Millstone Nuclear Power Station, Unit No. 3  
Transmittal of Amendment to FSAR/ER  
Docket No. 50-423

Millstone Nuclear Power Station, Unit No. 3  
Transmittal of Amendment 4  
to the Environmental Report

As committed in Reference (1) and in accordance with 10 CFR 50.30 (c)(1)(iv), Northeast Nuclear Energy Company, herewith submits Amendment 4 of the Environmental Report (ER).

FIGURE Q240.1-1  
ONE PERCENT CHANCE FLOOD LIMIT  
IN THE VICINITY OF THE MILLSTONE 3  
SITE PRIOR TO CONSTRUCTION  
MILLSTONE NUCLEAR POWER STATION  
UNIT 3  
ENVIRONMENTAL REPORT  
OPERATING LICENSE STAGE

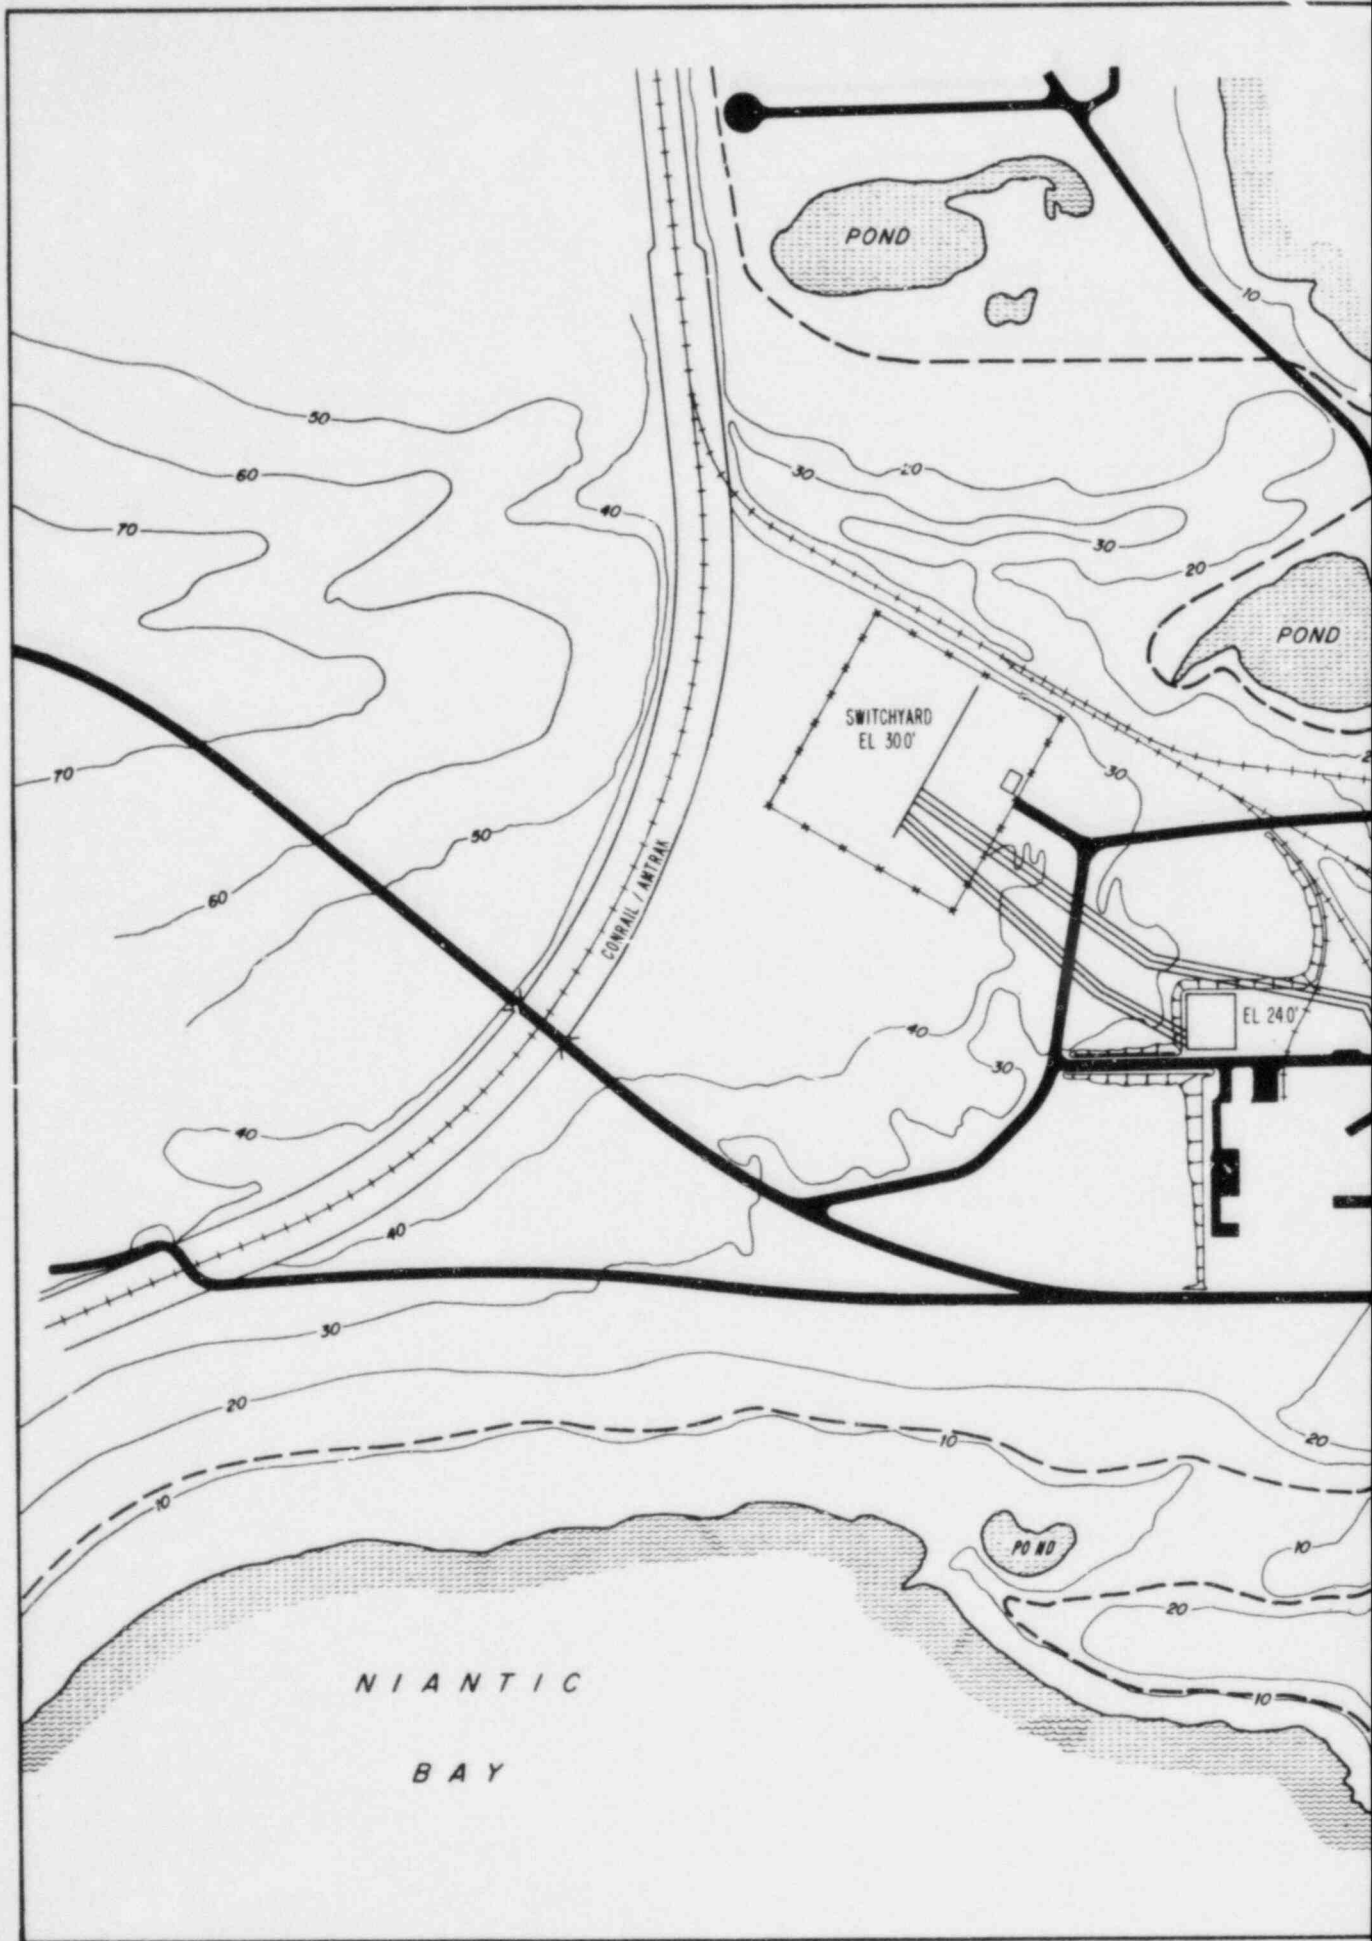
- a. Provide descriptions of the floodplains adjacent to the site. On a suitable map(s) provide delineations of those areas that will be flooded during the one percent (100-year) flood, both before and after plant construction or operation.

- a. The peninsula is flanked by Niantic Bay to the west and Jordan Cove to the east, both of which are extensions of Long Island Sound. Flooding at the plant site is caused by storm induced high water in Long Island Sound. The one percent chance storm-tide elevation is 10.7 ft NGVD. The coincident floodplain with this elevation prior to construction is shown on Figure Q240.1-1. The floodplain is mostly limited to the coastal perimeter of the site. One area with more extensive flooding is a low lying neck of land just west of the

FIGURE Q240.1-2  
ONE PERCENT CHANCE FLOOD LIMIT  
IN THE VICINITY OF THE MILLSTONE 3  
SITE AFTER PLANT CONSTRUCTION  
MILLSTONE NUCLEAR POWER STATION  
UNIT 3  
ENVIRONMENTAL REPORT  
OPERATING LICENSE STAGE

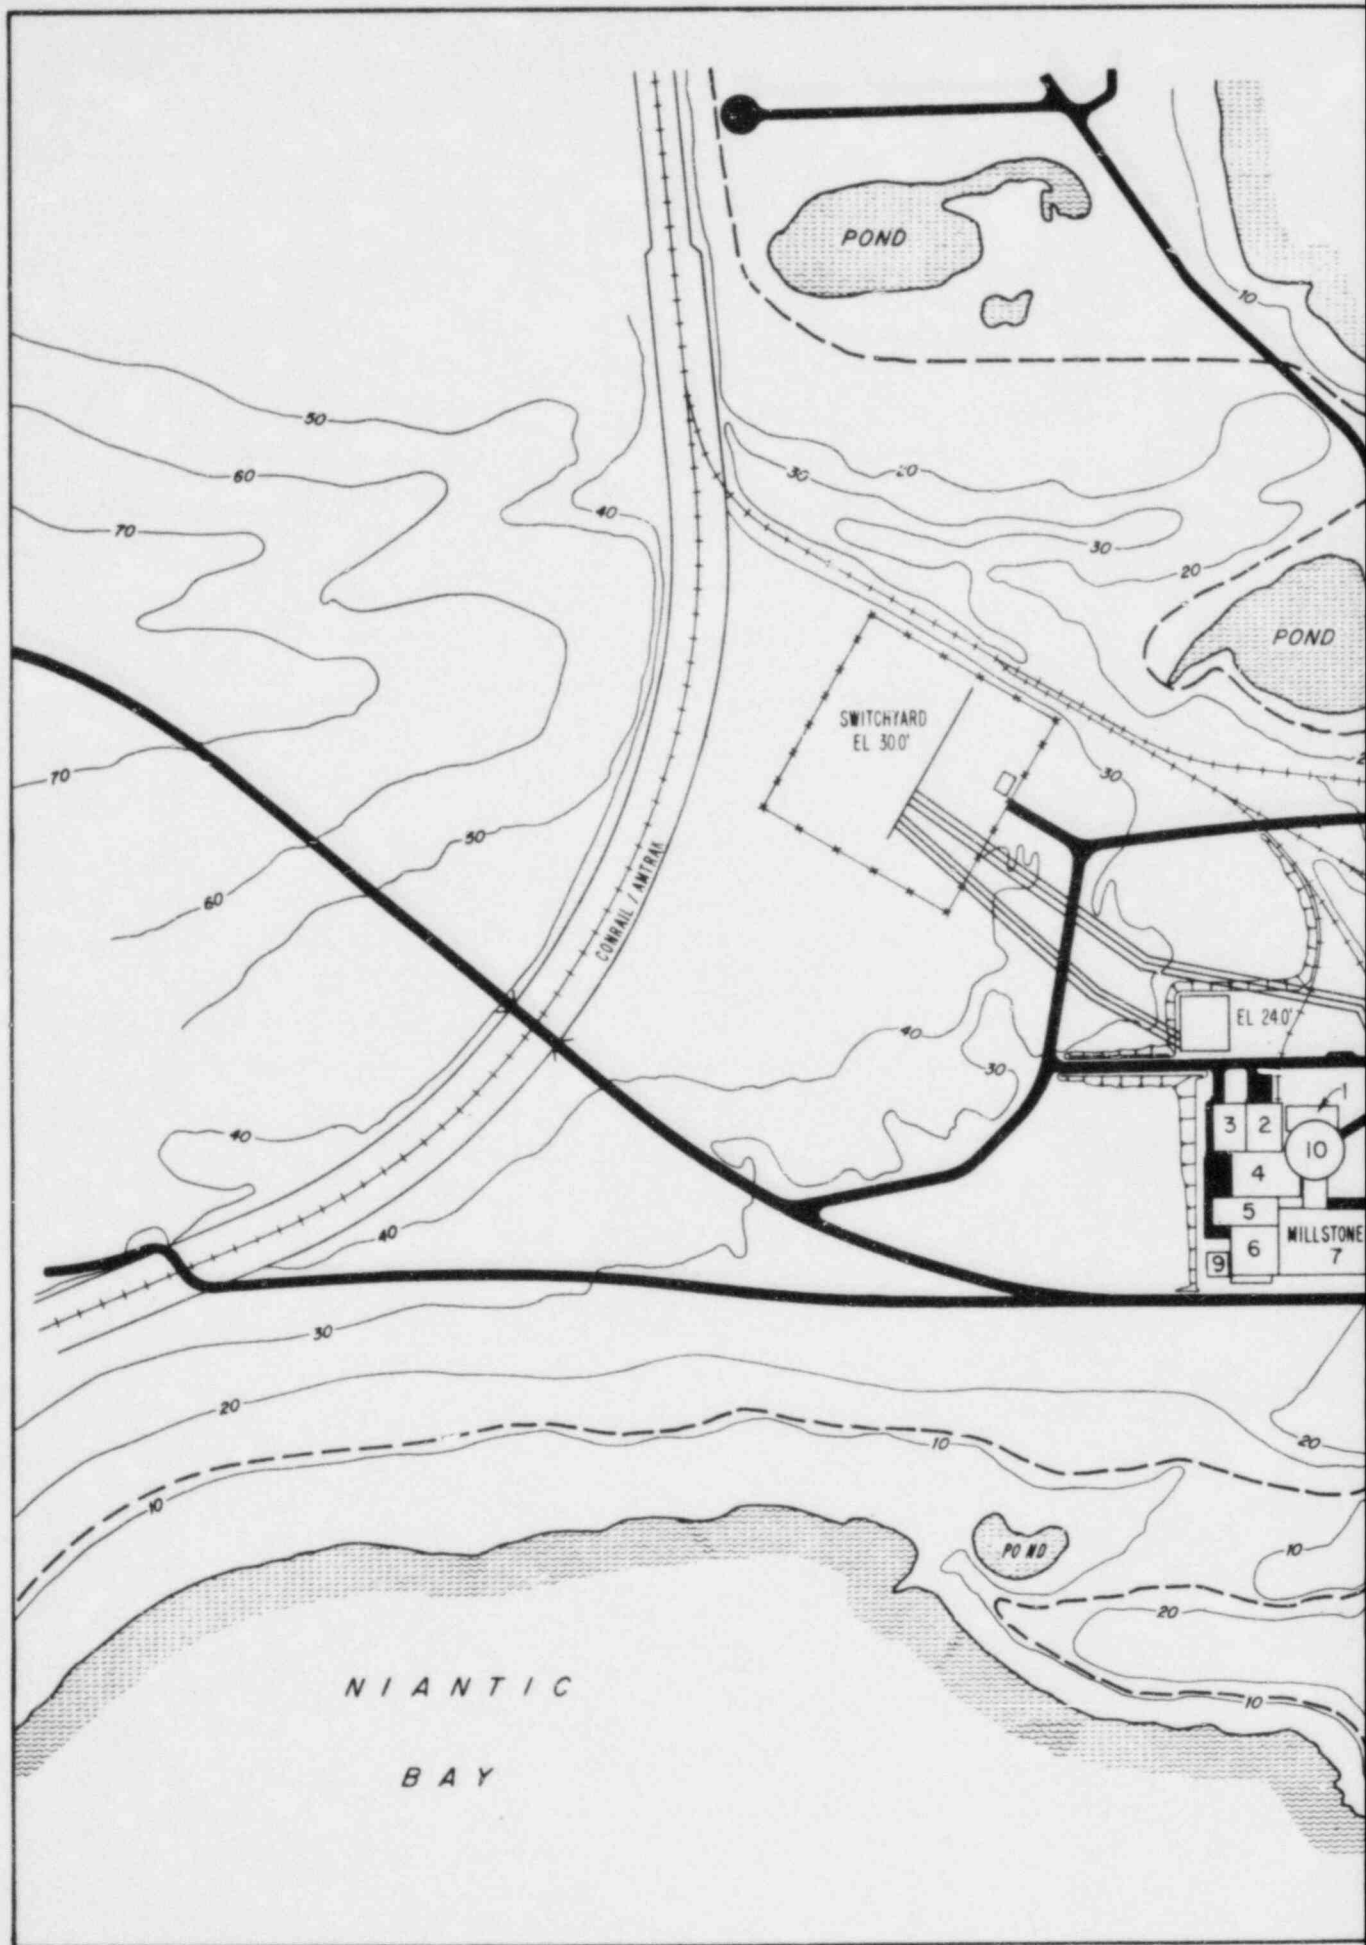
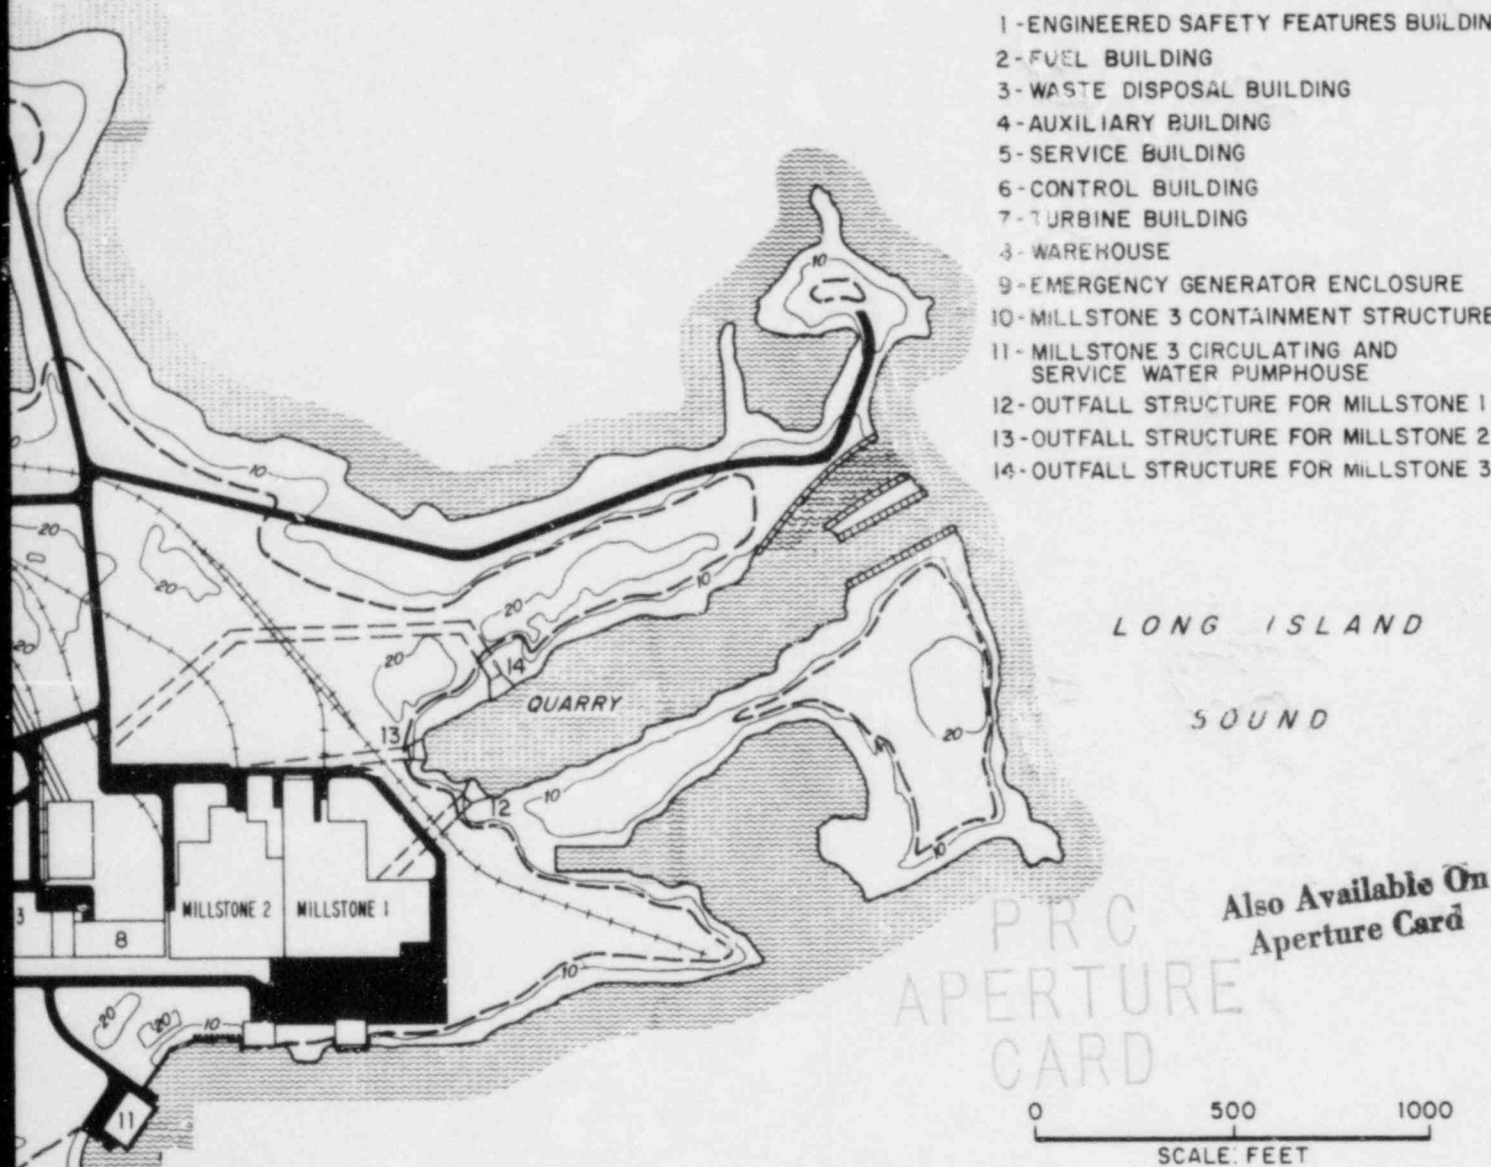
- c. Identify, locate on a map and describe all plant structures and topographic alternations in the floodplains.
- d. Discuss the hydrologic effects of all items identified in response to c. above. Discuss the potential for altered flood flows and levels, offsite. Discuss the effects on offsite areas of debris generated from the site during flood events.

quarry. The floodplain also inundates large areas just to the east and west of the station. Figure Q240.1-2 shows the floodplain after plant construction.

- c. Figure Q240.1-2 shows the floodplain with plant structures in place. The outfall structure, the circulating and service water pumphouse, and the new discharge canal are partially in the floodplain. Details of site grade revisions for these three facilities are given in Figures Q240.1-3, Q240.1-4, and Q240.1-5.
